GROWER'S CHOICE

This letter is to in response to your mail dated on Dec 1st, 2017 regard about requesting additional information for our exempt distribution license.

**PLEXUS SCIENTIFIC CORPORATION
RADIOLOGICAL SURVEY FORM**

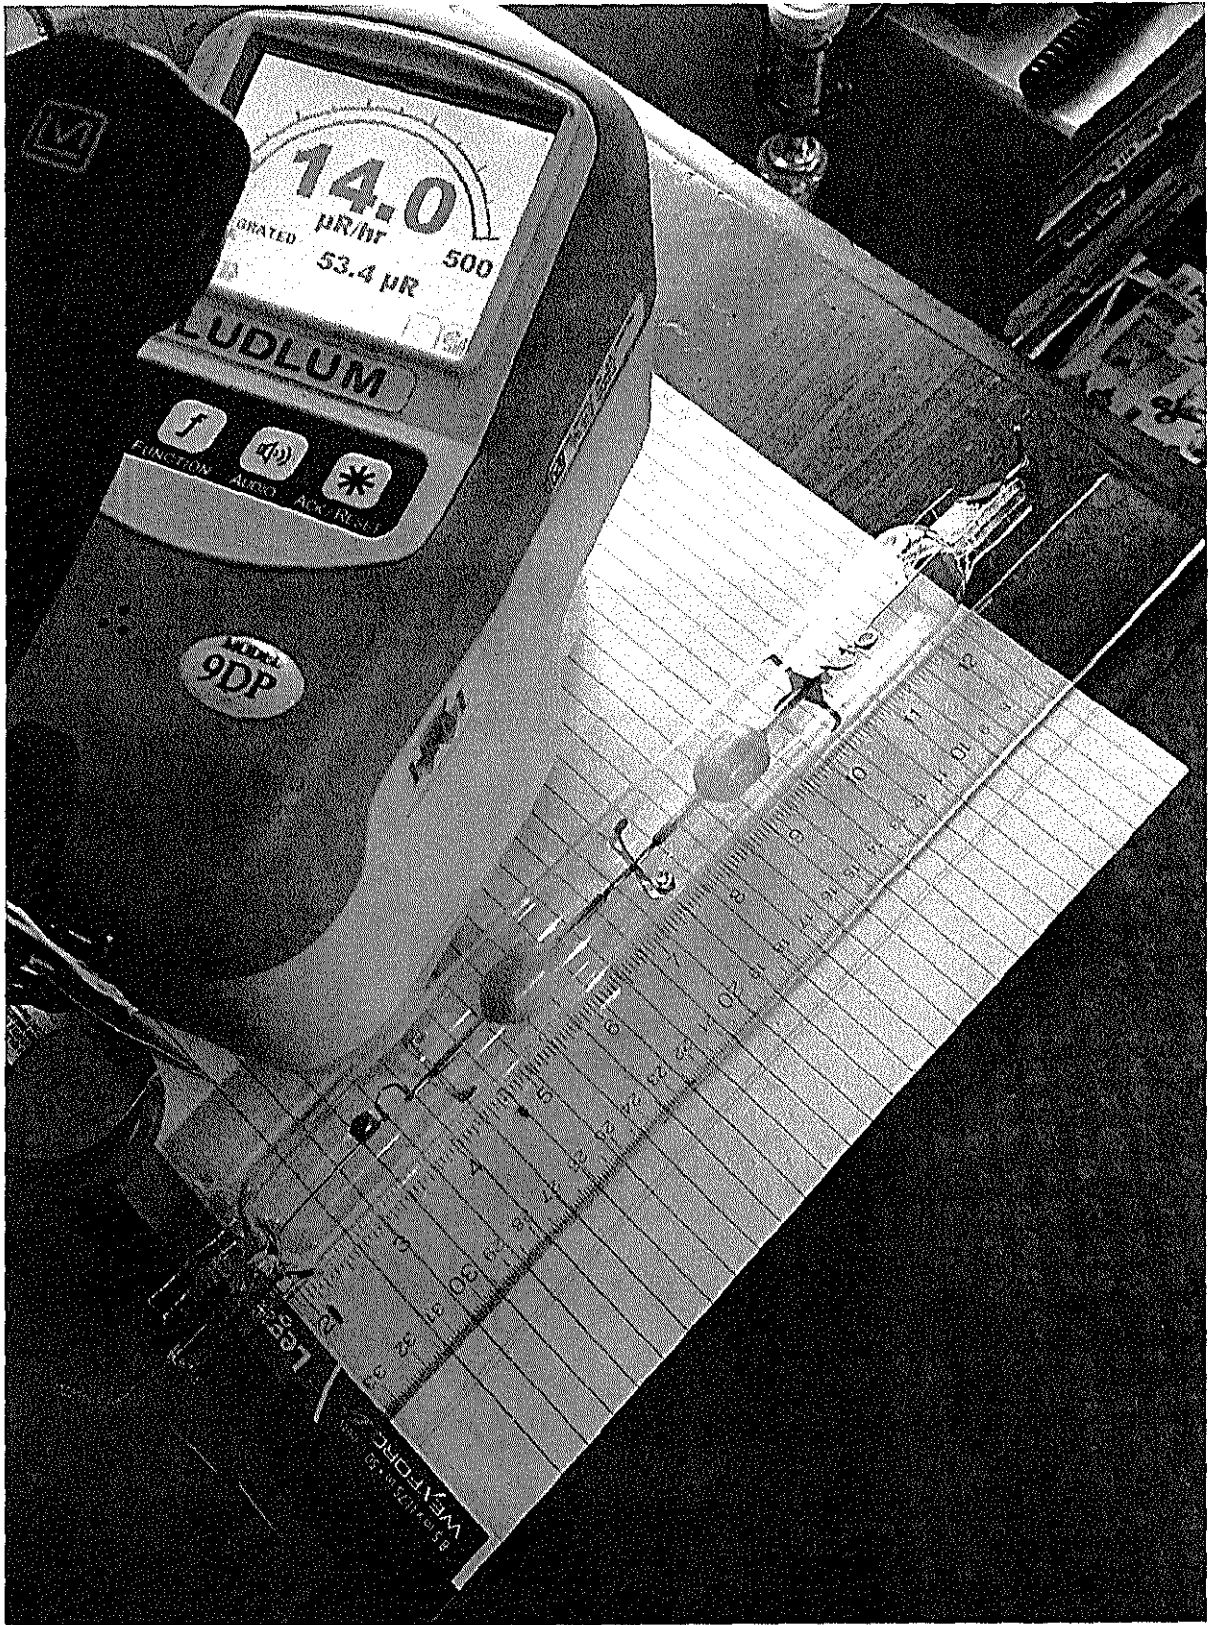
6. Please indicate how you made this determination; i.e., your method of measurement or calculation.

All of calculation and method of measurement is made by the consulting company PLEXUS SCIENTIFIC CORPORATION RADIOLOGICAL SURVERY FORM. They are one of the certify organization that has the ability to perform this kind of measurement.

Notes: Background Readings 11 μ R/hr - 15 μ R/hr.

- All lamps readings equal to background levels.
- Photographs attached
- Instrument Cal. Serv. Certificate attached.
